# SERVICE BULLETIN

| PURPOSE : CHANGE | ISSUE NO. : MSB-14EXML00-002A | DATE : 2014-02-25 |
| SUBJECT : SPLASH SHIELD REMOVAL AND INSTALLATION & OVERFENDER REMOVAL AND INSTALLATION | | <DESTINATION/MODEL> (As per attached sheet 1) <M/Y> 13-14 |
| GROUP : GENERAL(Gr:00) | | OUTLANDER/OUTLANDER PHEV(GF0W) |

Attached sheet 2

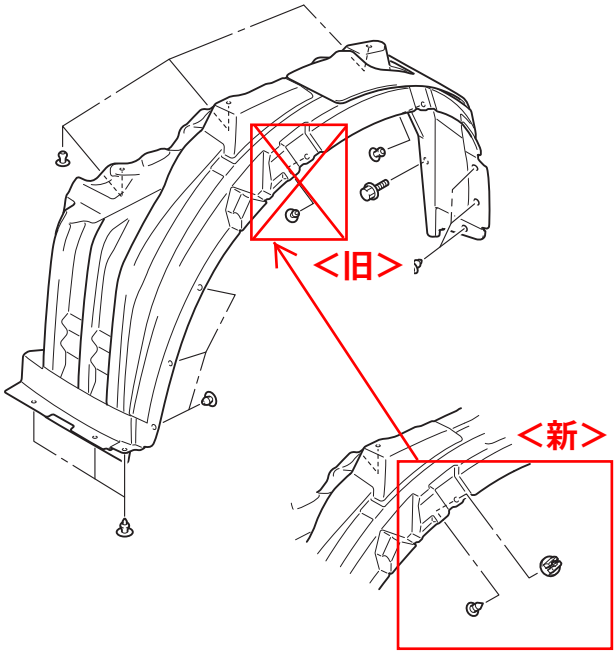
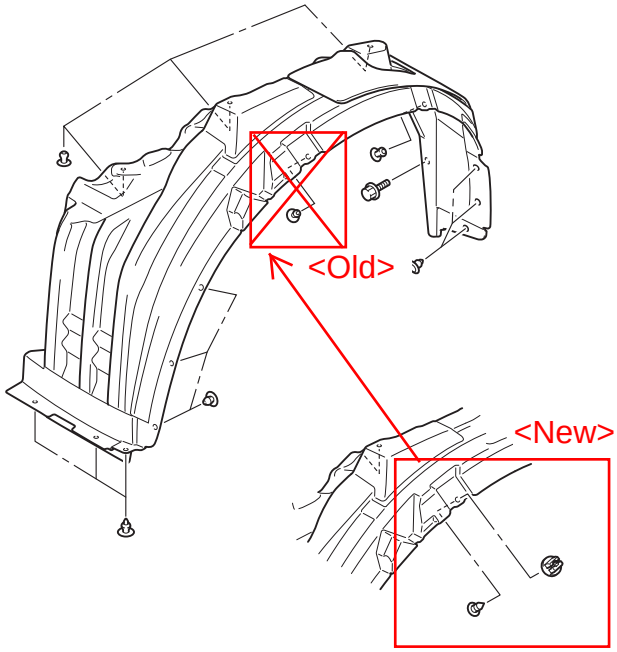
**上図のようにクリップからグロメットスクリューへ変更すると共に，フェンダー側のスプラッシュシールド取付け穴を丸穴（Φ6）から四角穴（□8.5）に変更した。**

As shown above, a grommet screw is used instead of the clip, and the splash shield mounting hole at the fender side is a rectangle hole (8.5×8.5 mm) in place of the round hole (diameter: 6 mm).

### <<A>> FRONT BUMPER MOULDING REMOVAL

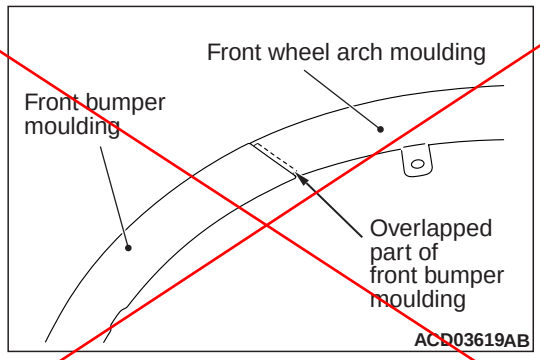
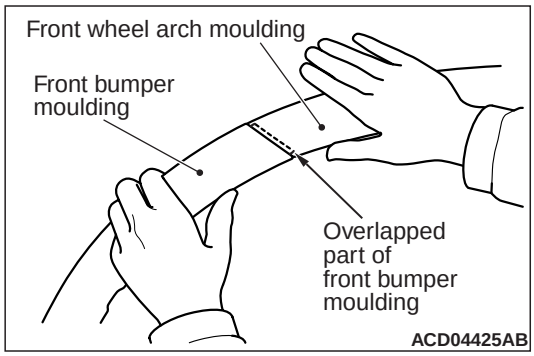
**Note that the front wheel arch moulding and the front bumper moulding overlap.**

Insert A of the attached sheet 3(4/4).

**As the front wheel arch moulding and the front bumper moulding overlap, hold the front wheel arch moulding with hand when removing the front bumper moulding to prevent deformation.**

### <<B>> REAR BUMPER MOULDING REMOVAL

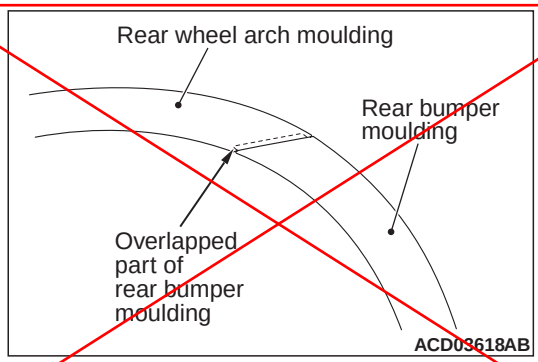
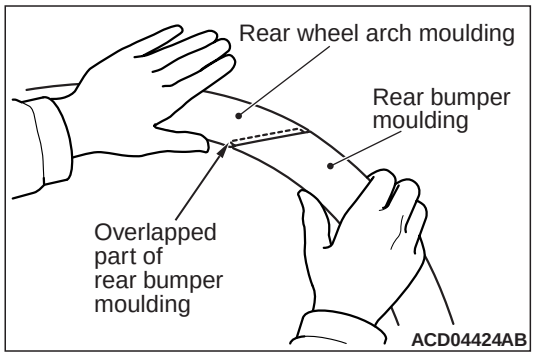
**Note that the rear wheel arch moulding and the rear bumper moulding overlap.**

Insert B of the attached sheet 3(4/4).

**As the rear wheel arch moulding and the rear bumper moulding overlap, hold the rear wheel arch moulding with hand when removing the rear bumper moulding to prevent deformation.**
